REVISED/	ISSUED/	PLOTTED	DATE
▲	ADDENDA	REVISION	8 MARCH 2012

PEGUIS PAVILION
 UPGRADES AND ADDITION
 KILDONAN PARK, WINNIPEG MB
 project
 LOWER FLOOR PLAN
 REFLECTED CEILING PLAN
 sheet title
 consultant

seal
 drawn by: KDS
 checked by: RB
 project no. 2011026
 scale: 3/16"=1'-0"
 date: 23 NOV 11
 sheet no. **A1.4**

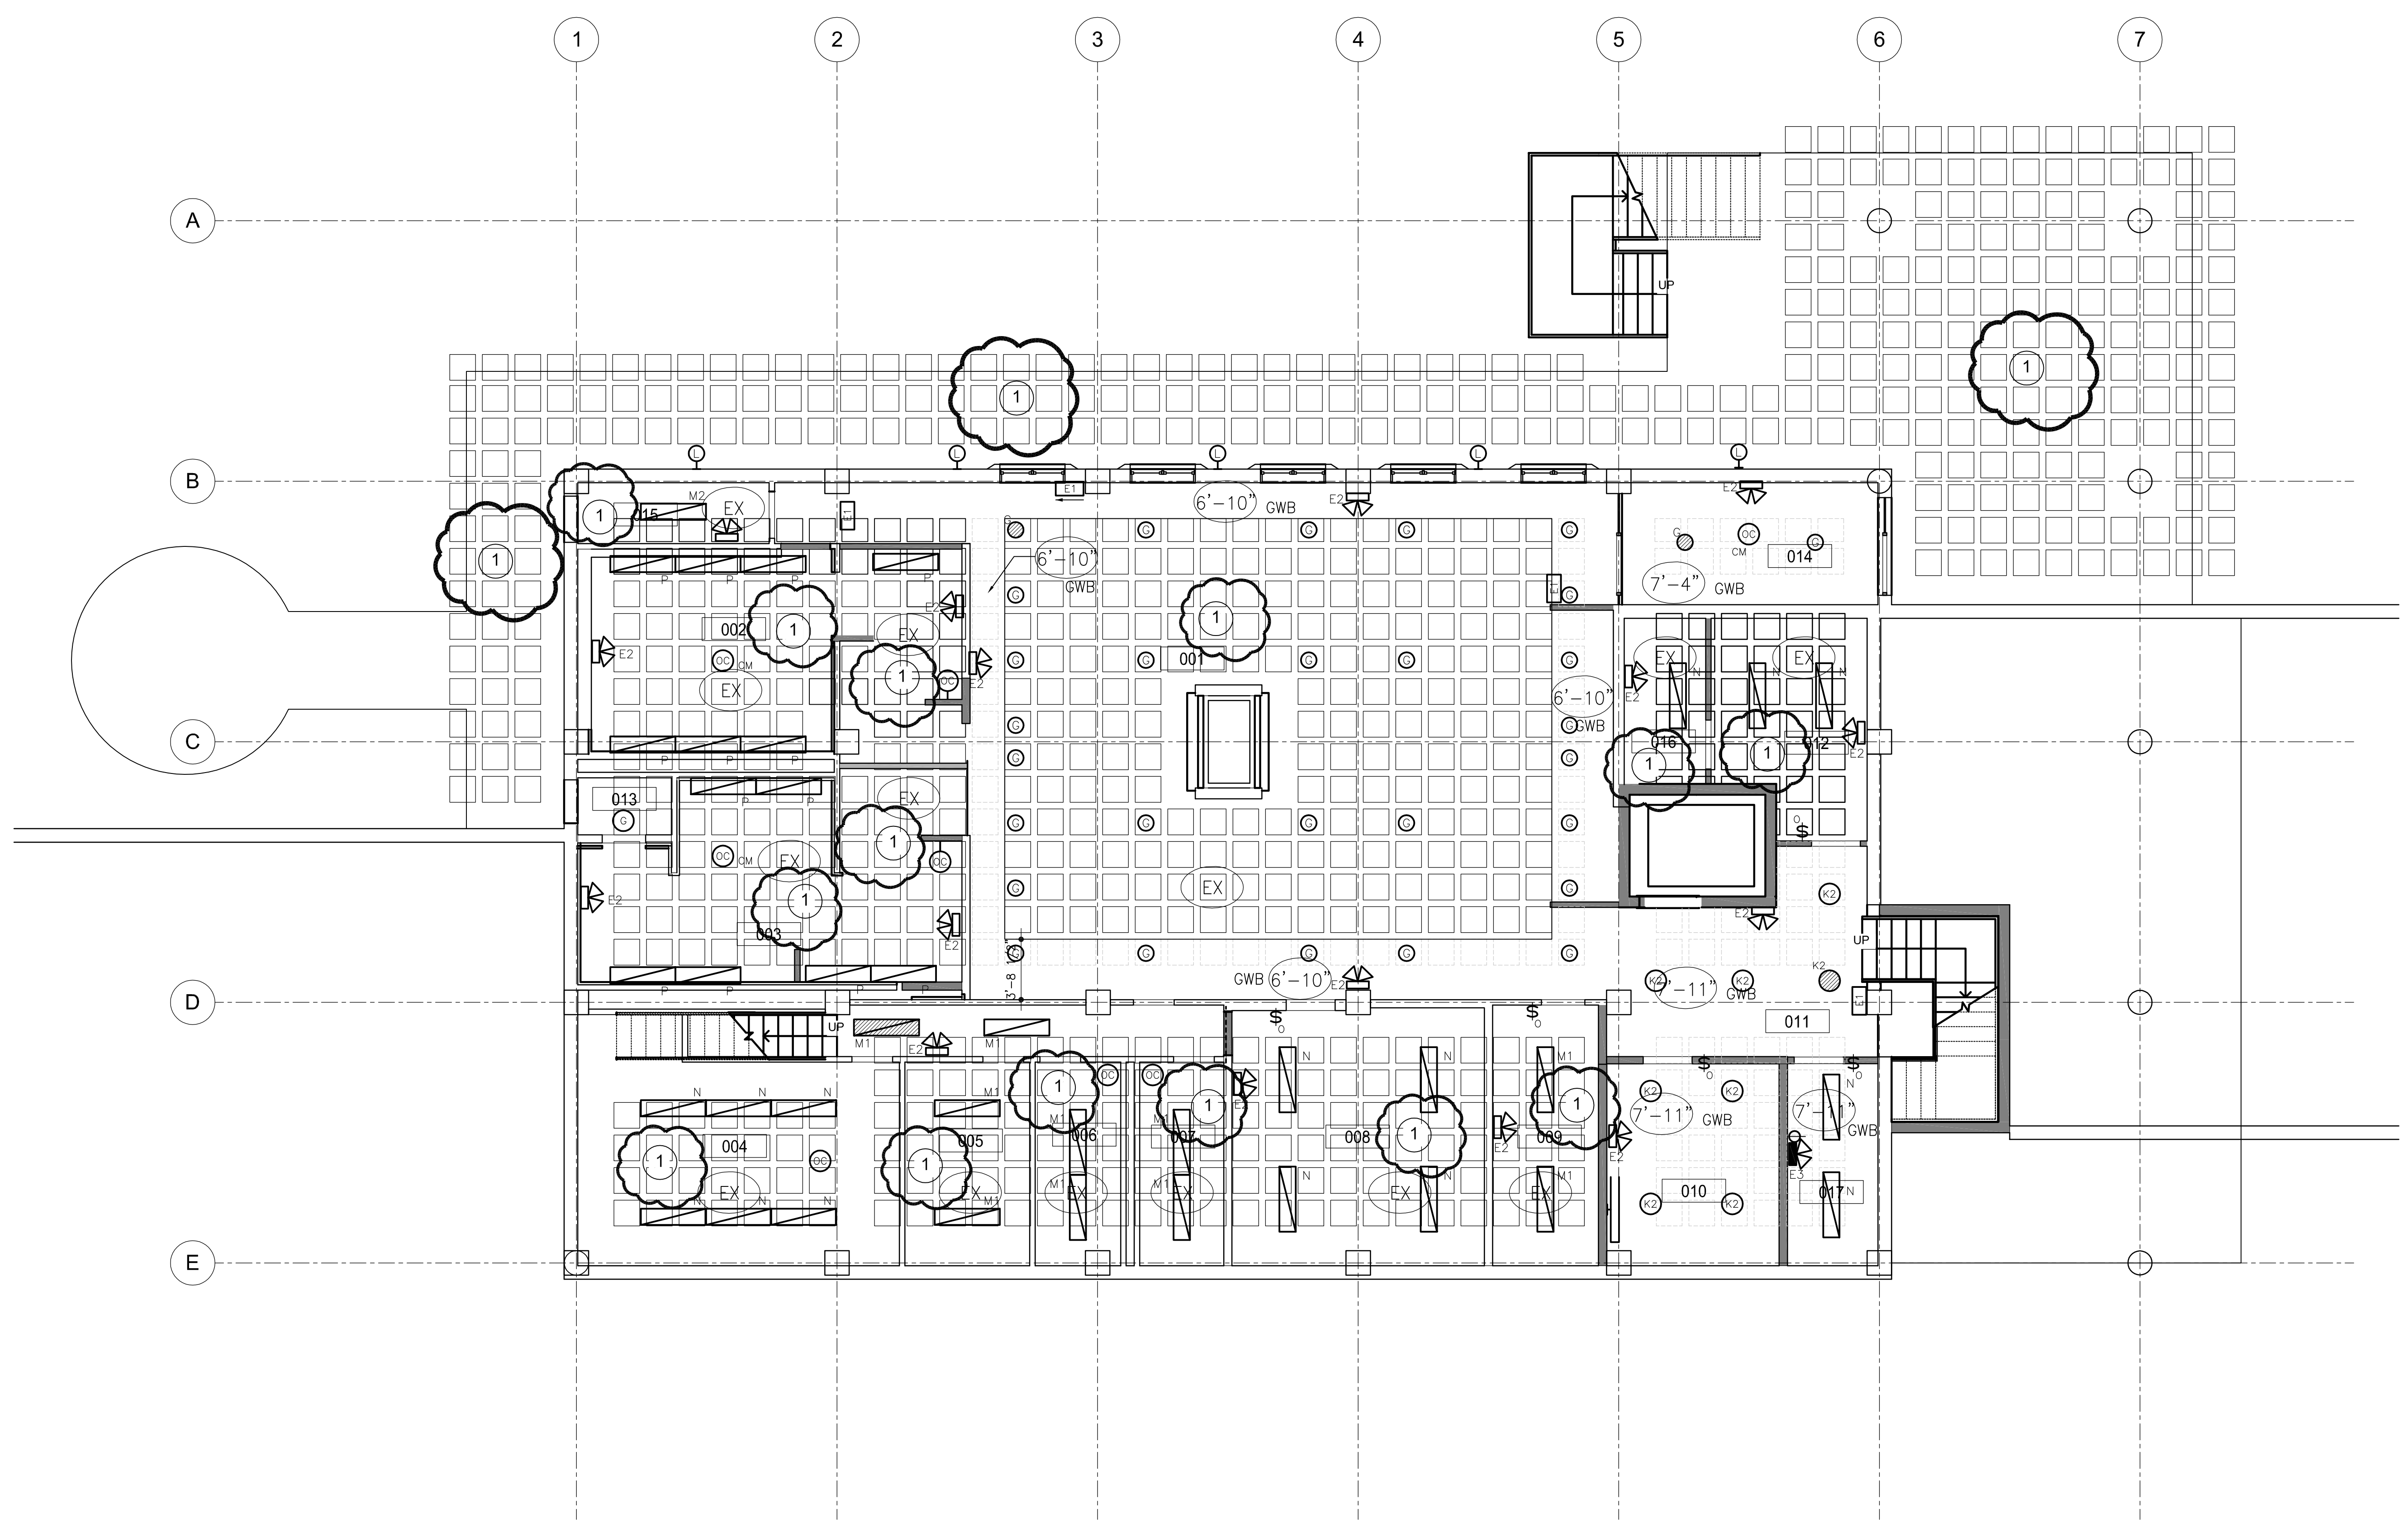
1 GENERAL NOTES
 ① ALL EXPOSED WAFFLE SLAB TO BE PAINTED.
